22-COA-0045 2246 Grinstead Dr.

Cherokee Triangle Architectural Review Committee
Public Hearing

Bradley Fister, Historic Preservation Specialist May 18, 2022

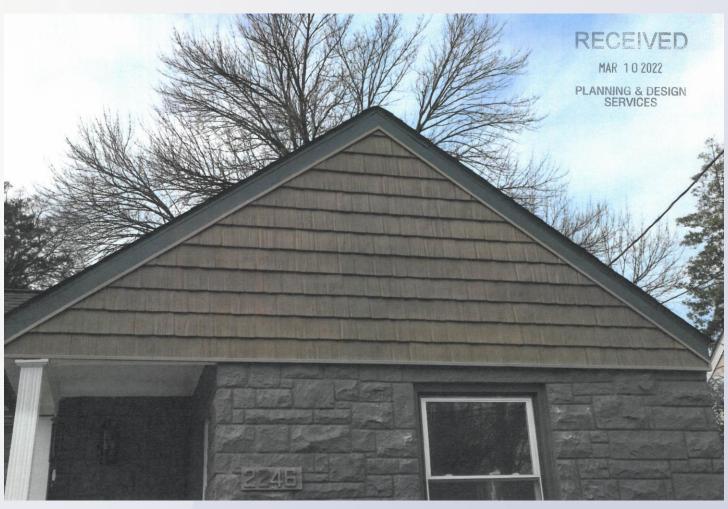
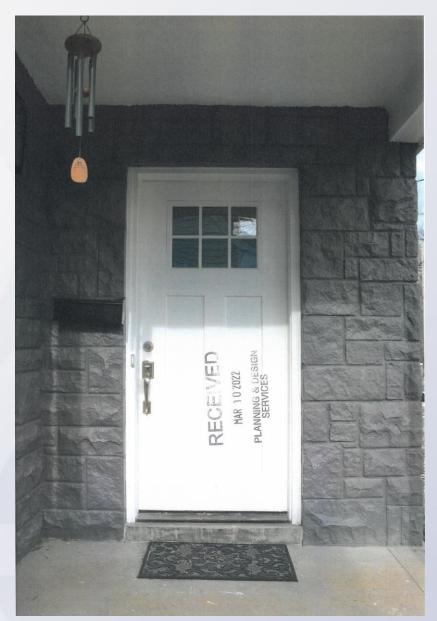
• The applicant requests after-the-fact approval to replace the 5" reveal synthetic lap siding under the front facing gable, with a synthetic siding that mimics the look of wood shake siding.

- 1. The applicant shall remove the existing synthetic shake siding and replace it with 5" lap siding within two years of approval of the Certificate of Appropriateness by the Cherokee Triangle Architectural Review Committee.
- 2. The applicant shall contact staff if the scope of the project were to change, and before the applicant makes any other exterior changes to the property.
